RENESAS TECHNICAL NEWS

No. M16C-95-0304

Precaution for the Use of the Three-Phase Motor Control Timer Functions

Figure 1.   Example waveform when a value is set in the TAi-1 register shortly before and after the timer Ai underflows

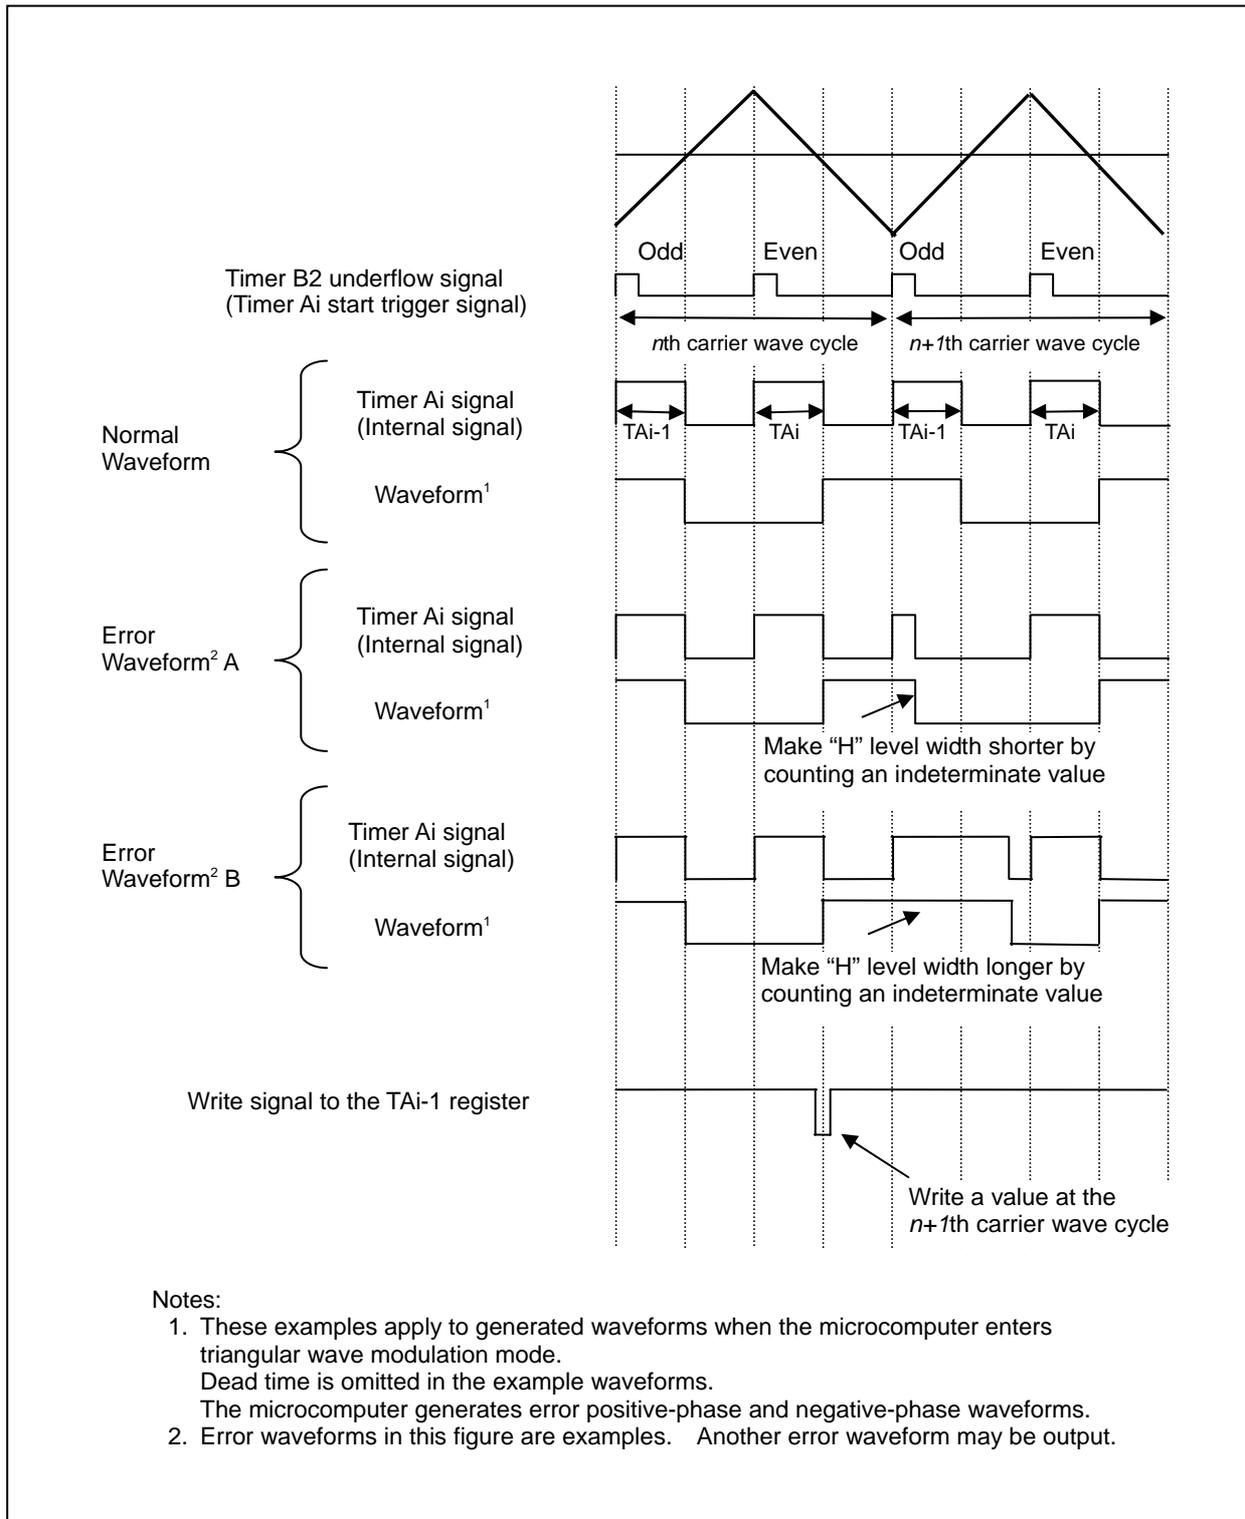
The microcomputer may generate unexpected waveforms when modifying TAi-1 (i=1, 2 and 4) register settings if all the following conditions are met while using the three-phase motor control timer functions.

Conditions (See Figure 1)
- The INV11 bit in the INVC1 register is set to "1" (Three-phase mode 1).
- A value is set in the TAi-1 register shortly before and after the timer Ai underflows.

Set the value in the TAi-1 register, then rewrite the same value in the TAi-1 register after one cycle of the timer Ai count source has elapsed.

Notes:
1. If the TCK0 and TCK1 bits in the TAiMR register are set to "0" (count source f1) and the CPU clock runs in the same cycle as the timer Ai count source, the value can be rewritten immediately after the TAi-1 register is initially written.
